RECORD OF INSPECTION OF DAM

NAME OF DAM Argonaut

Argonaut Dam, No. 478 (OJ)
Amador

ARGONAUT MINE TAILINGS DAM, JACKSON, CALIFORNIA

Section of Face of Argonaut Mine Dam

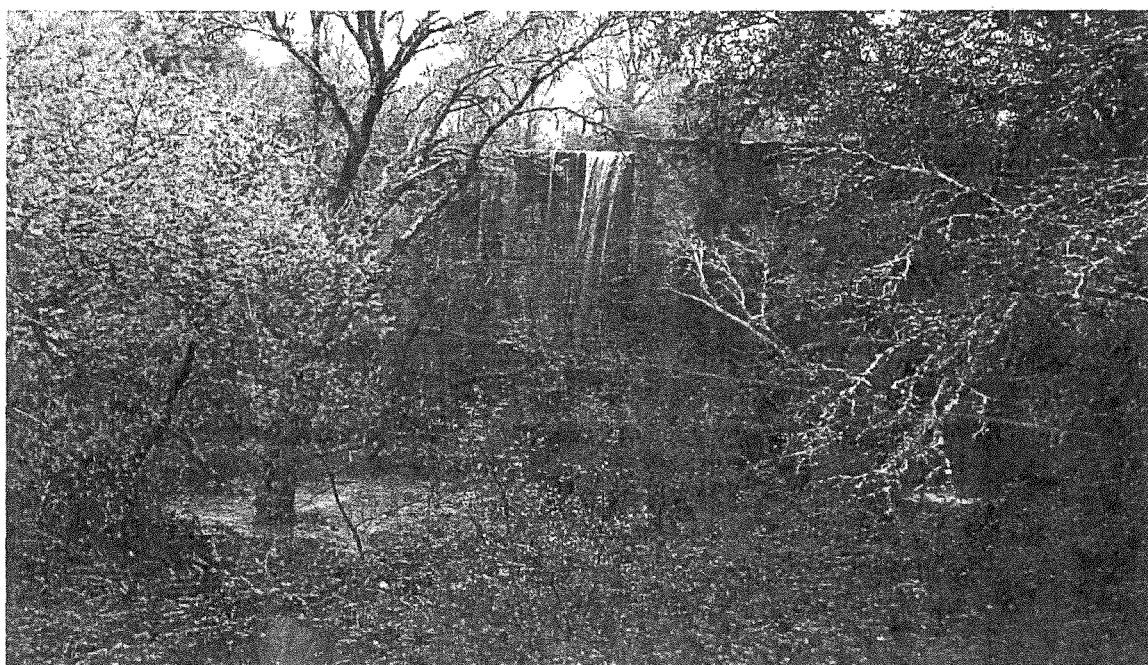
The Argonaut Dam is listed as being 46 feet in height. It was built to contain the tailings and debris from the Argonaut Mine activities from entering Jackson Creek. At the last site visit in 2009, the material behind the dam was within four feet of the top of the dam. During heavy rains, water circumvents the dam to the south and also pours over the top of the dam (I have enclosed a picture of this happening). DTSC took soil samples from behind the dam to analyze for arsenic contamination. These borings were up to a depth of 35.5 feet below ground surface (bgs). The soil borings indicate that at a depth of 34 feet bgs the tailings were wet which increases the ability of the tailings to flow. The dam is located in a steep ravine/creek bed which ends near Highway 49 and across from the commercial area of the city of Jackson. There is a potential for the dam to fail and tailings to move down gradient along the creek bed or Sutter Road to Highway 49.

Close-up of blackberry bushes growing in cracks in dam.

Rain water runoff flowing over the top of Argonaut Mine, April 4, 2006.

This letter is to inform both the land owner and the Amador County Public Works Department of the observed condition and possible consequences of a failure of the Argonaut Dam. It may be prudent for responsible entities to assess the need to take preventative measures associated with the condition of the dam.

ARGONAUT DAM - No. 478

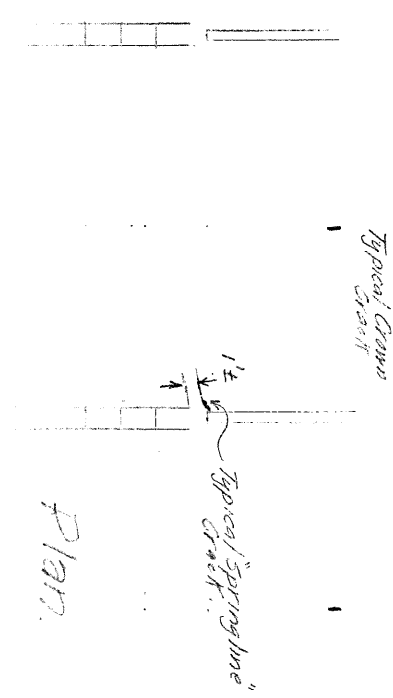
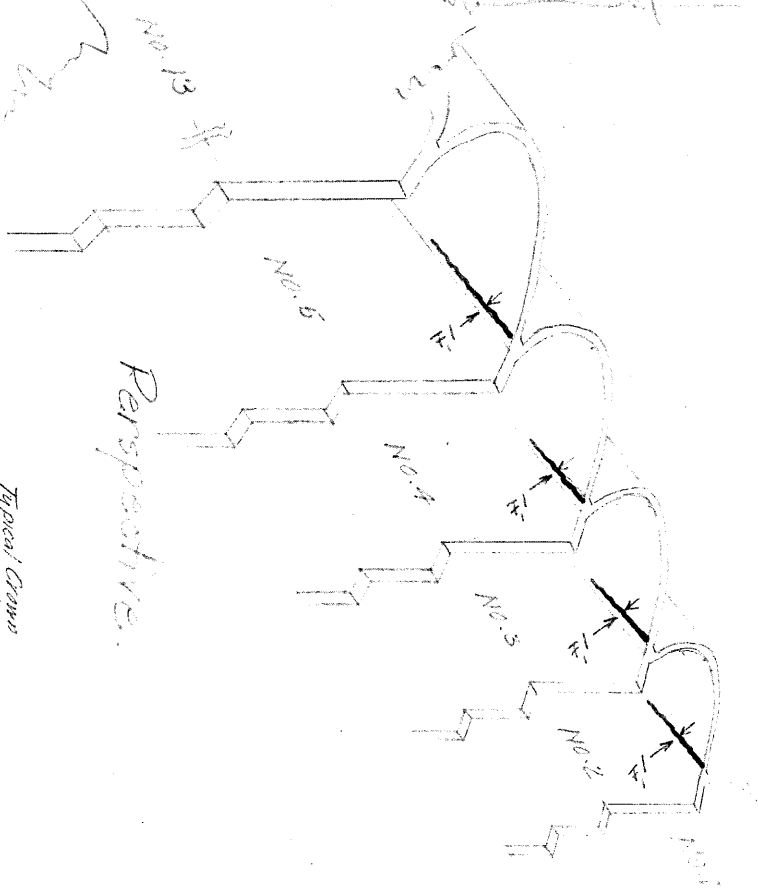
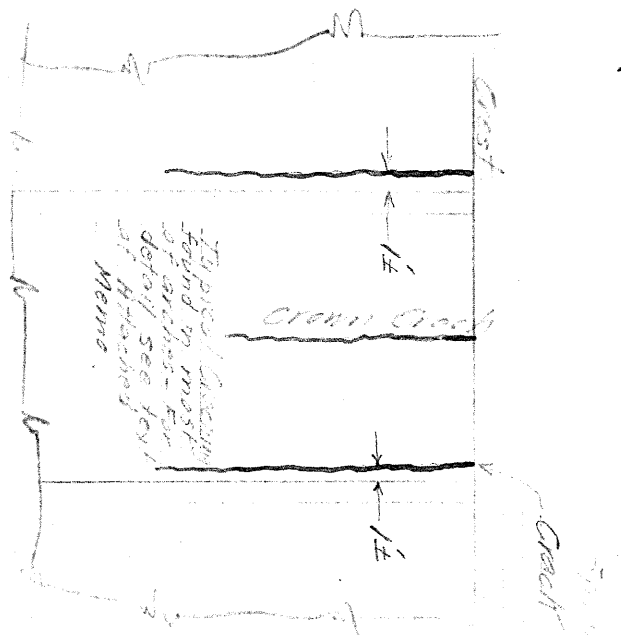
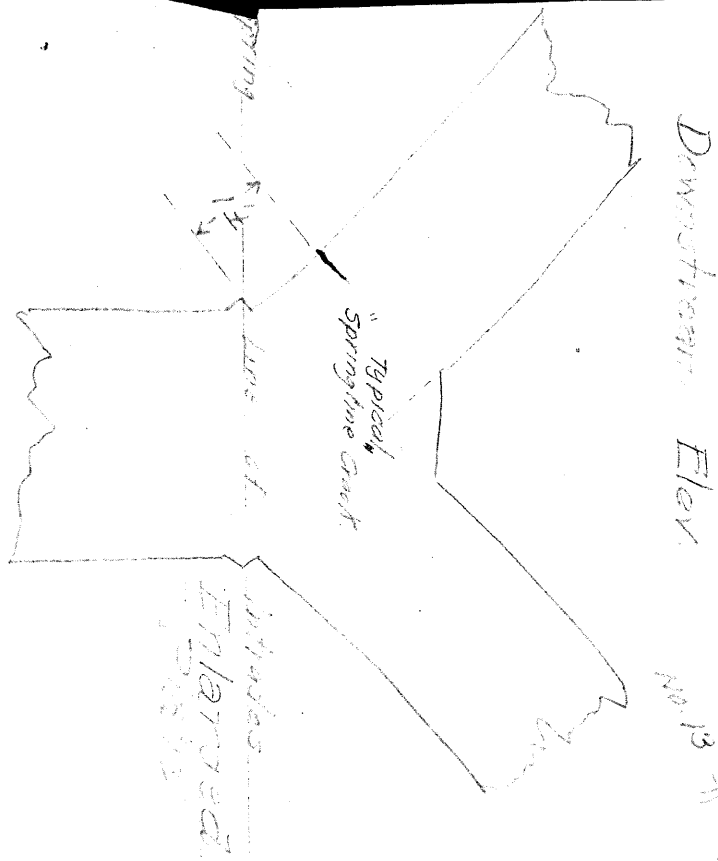
An examination of the downstream face of the dam disclosed crown cracks in most of the arches and cracks about 1 ft. parallel to the springing line of the extrados. It is significant that these latter occur for the most part near and parallel to the spring line on the right end of the arches (looking upstream). The general condition and location of both crown and "spring line" cracks is shown on the attached sketch in perspective, plan and elevation.

Both crown and "spring line" cracks begin at the crest of dam and extend downward for vertical distances which are more or less indeterminate since the cracks seem to be open a maximum at the crest and gradually play out as hair cracks or terminate at a construction joint or joint between successive concrete pours. They are usually traceable for a distance of 10 feet or more.

- Arch #2 - Crown crack and "spring line" cracks at both ends of arch.
- Arch #3 - " " " " " " " " " "
- Arch #4 - A skewing crown crack.
- Arch #5 - A partial crown crack.
- Arch #6 - A "spring line" crack on the right from crest about 10 feet down, and a crown crack.
- Arch #7 - "Spring line" crack on right.
- Arch #8 - Crown crack.
- Arch #9 - Slight "spring line" crack at right end. This arch leaks more than any of the others, the face being uniformly wet.
- Arch 10 - Crown crack top to bottom. A typical diagonal buttress crack is found in buttress between arches 9 and 10.
- Arch 11 - "spring line" crack on right end from crest to 15-20' down.
- Arch 12 - "Spring line" crack on right and crown crack.

If these cracks did not exist at time of former inspections (roughly a year ago) then something has happened to the structure since then. The recent earthquake disturbance centering in Nevada (approximately 2 months ago) may have influenced the present condition. There is also a possibility of local earth movement due to

Photo #1.
Crack at left end of arch 1-2.

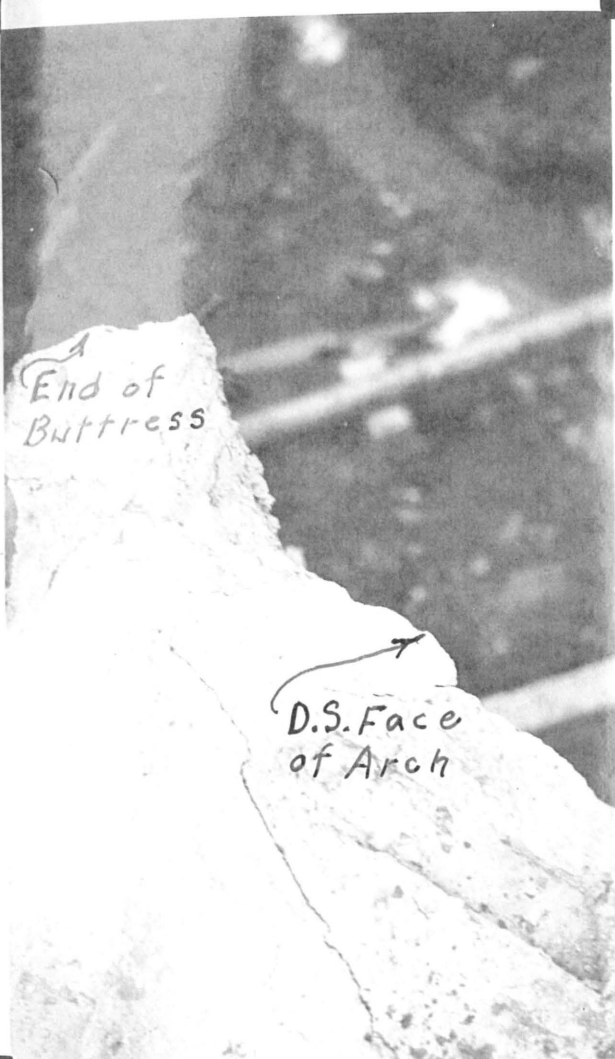
The downstream view of the cracks at the left end of arches 1-2 and 2-3 counting from the left end of the dam is shown in photos #1 and #2. Arch 2-3 is the only one which shows a similar crack at the right end. Photo #3, at the top of buttress #7, shows the typical appearance of the cracks at the top of the arch. These cracks can be traced for a distance of only 12 or 15 feet downward from the top of the dam.

The strut extending through the six higher bays (5 to 10, incl.) shows good continuity without cracking except at the two ends, where it has pulled away from its anchorage at the buttresses, leaving a crack of 1/4" in width.

At the left end there is a slight displacement downward and upstream of the strut with respect to the buttress. Photo #4 shows the condition at the left end of the strut.

ARGONAUT MINE DAM.
No. 478
March 24, 1931.
G.MCK.

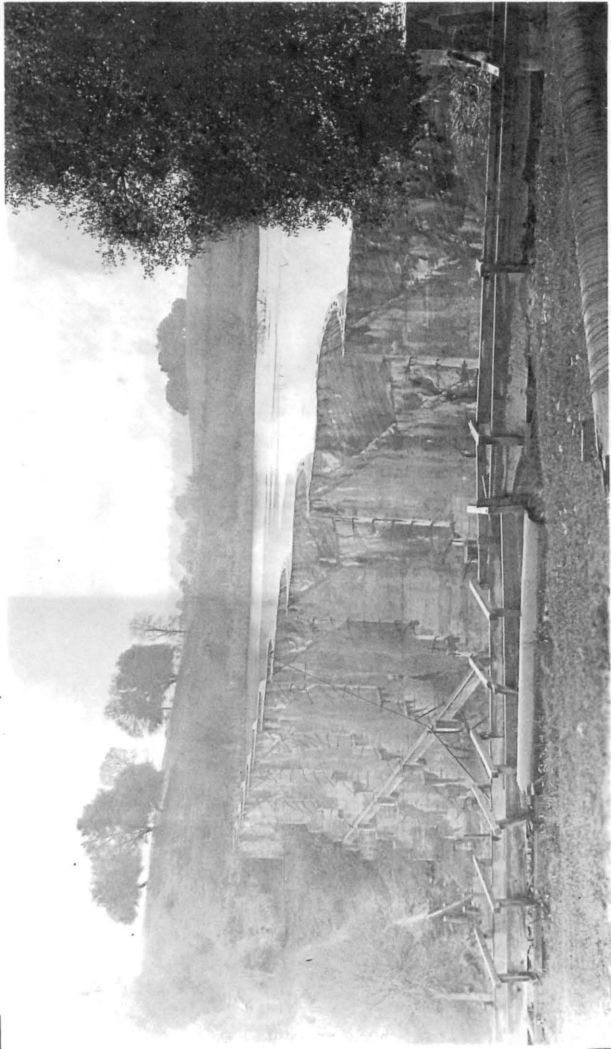
This inspection was made to verify the owners communication stating that the spillway had been rendered serviceable by cleaning out tules in the entrance. Such was found to be the case and it is believed that nothing stands in the way of the approval of this structure.

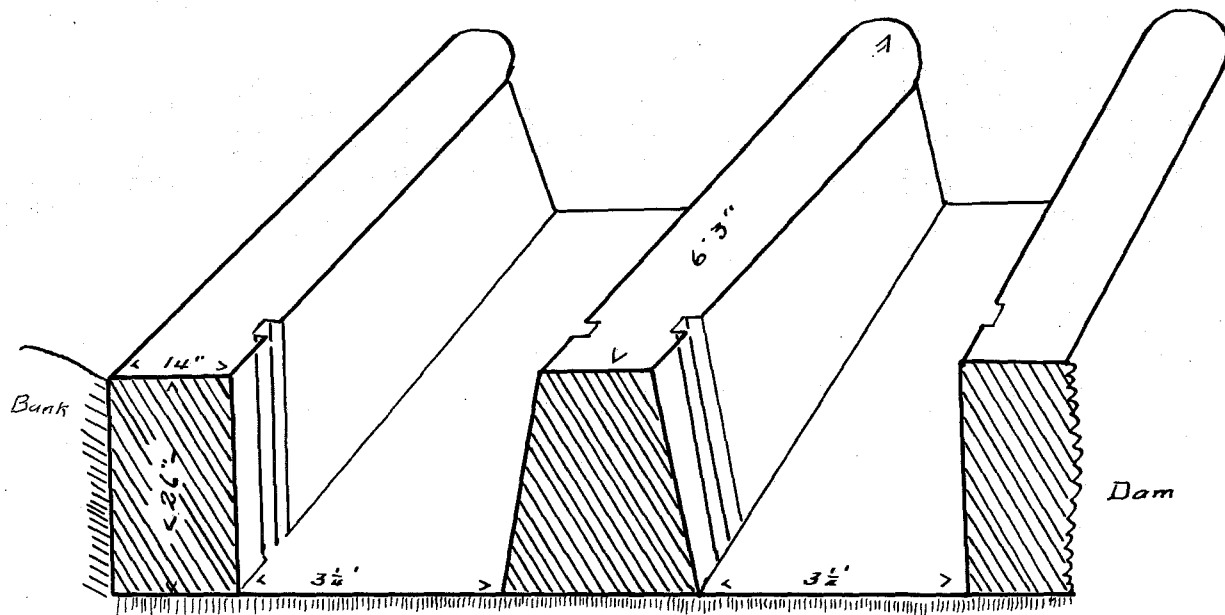
re. Argonaut Dam (#478) the spillway has been cleared
and a new floor put in by-pass to spillway
